**Information importante pour ceux qui ont acheté les fixations pour skis roues Rottefella en 2020 ou 2021.**

Important information for those who have purchased Rottefella roller ski bindings in 2020 or 2021

**The new security lock works in the following way:**

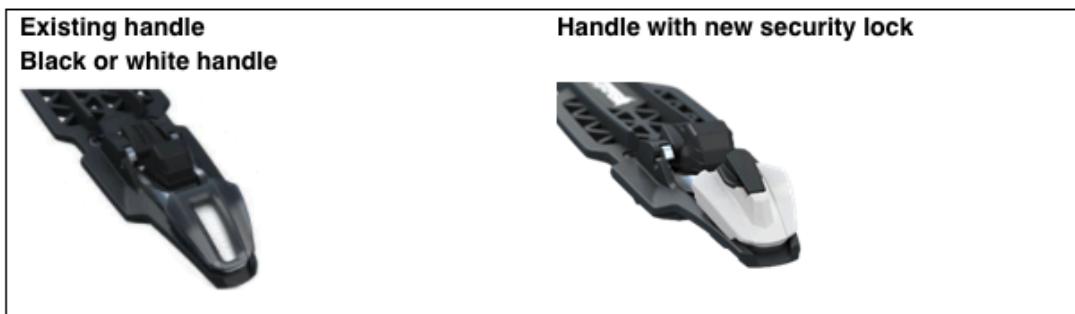
Nous avons eu des incidents au niveau du verrou de sécurité supplémentaire de la fixation de skis roues, qui ne fonctionne pas correctement, et nous le regrettons. Rottefella a maintenant développé un nouveau verrou de sécurité, il verrouillera mécaniquement le mécanisme d'ouverture/fermeture tout en continuant à être facile à utiliser. Nous encourageons tous ceux qui ont acheté les fixations de skis roues Rottefella en 2020 ou 2021 à changer leurs fixations existantes pour les nouvelles fixations avec le nouveau verrou de sécurité.

Le nouveau verrou de sécurité sera bientôt disponible. En attendant, nous vous encourageons à vérifier si la fixation «claqué» lorsque vous la verrouillez. Le «claquement» doit être important quand il est verrouillé, et vous devez sentir une résistance importante quand vous l'ouvrez. Si vous n'entendez/sentez pas le claquement quand vous verrouillez la fixation, nous vous recommandons par mesure de précaution supplémentaire, d'utiliser des attaches de câble ou du ruban adhésif autour de la fixation en position verrouillée.

<b>Step 1 Open position</b> 	<b>Step 2 Closed position, but not locked See red marking</b> 	<b>Step 3 Locked position Red marking is now covered</b> 
--	--	---

**The new security lock works in the following way:**

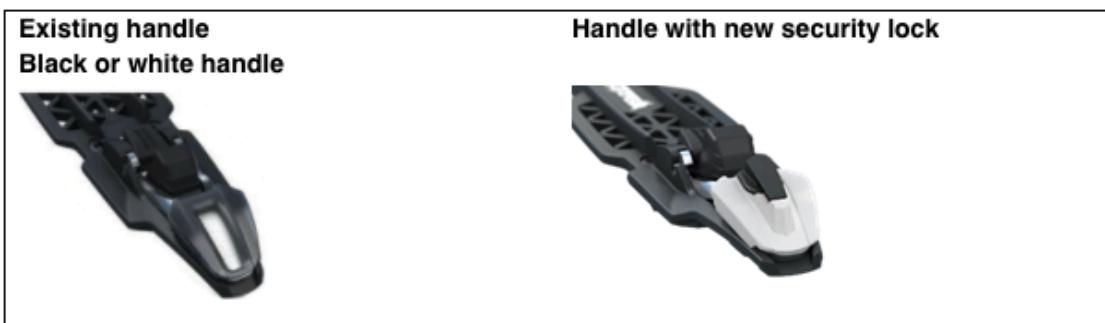
We have had some incidents where the extra security lock of the roller ski binding has not worked properly, and we strongly regret that. Rottefella has now developed a new security lock that will mechanically lock the open/close mechanism whilst continuing to be easy to use. We encourage all who have bought Rottefella roller ski bindings in 2020 or 2021 to change their existing handles to the new handles with the new security lock.

The new security lock will be available soon. In the meantime, we encourage you to check whether the binding «clicks» in place when you lock it. The “click” should be considerable when it locks, and you should feel considerable resistance when you open. If you do not hear/feel a click when you lock the binding, we recommend that you as an extra precaution use cable ties or tape around the handle in the locked position.

<b>Step 1</b> <b>Open position</b> 	<b>Step 2</b> <b>Closed position, but not locked</b> See red marking 	<b>Step 3</b> <b>Locked position</b> Red marking is now covered 
--	---	---
